SERVICE BULLETIN:
EFL5550
Fuselage/Vertical Tail Bulletin:

July 1, 2016

Product: Radian XL 2.6m BNF Basic (EFL5550) Fuselage/Vertical Fin

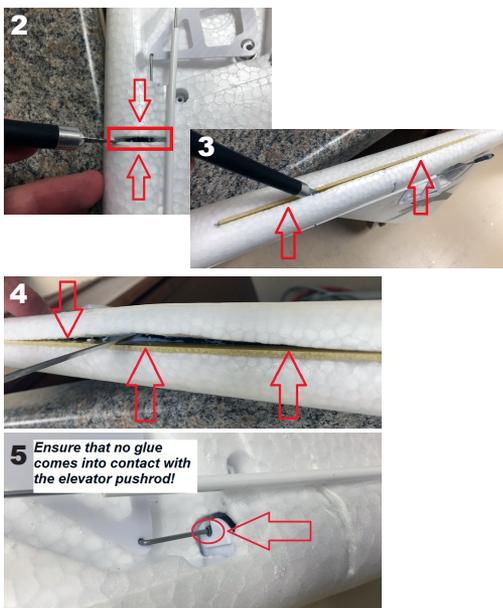
Issue: The fuselage/vertical fin may be loose (near the back/tail end of the fuselage).

What To Do: If there is no colored sticker located on either the outside of the product box near the UPC/barcode or on the bottom of the center wing panel, and if you find that the fuselage/vertical fin is loose and twists easily, perform the steps listed below.

Required: Thin CA (Cyanoacrylate) glue (odorless/foam-safe CA and the use of accelerator is not recommended), a hobby knife, Phillips screwdriver and flat head screwdriver Do not use Accelerator and give the glue time to fully cure before reassembly.

1. Use a Phillips screwdriver to remove the plate on the right side of the vertical fin.
2. Expose the black colored stiffener tube using a hobby knife to remove any white glue from the fuselage's right side slot (below the vertical fin).
3. Use a hobby knife to carefully cut the joint between the fuselage and the fiberglass stiffener plate (bottom of the fuselage). Cut all the way to the stiffener tube.
4. Use a flat head screwdriver to spread the joint between the fuselage and the plate. Apply a thin layer of CA inside the joint so it 'wicks' around the stiffener tube.
5. Apply a thin layer of CA in the slot on the right side of the fuselage and around the end of the stiffener tube. Ensure that no glue comes into contact with the elevator pushrod. Verify that the vertical fin is properly aligned before the glue sets/dries.
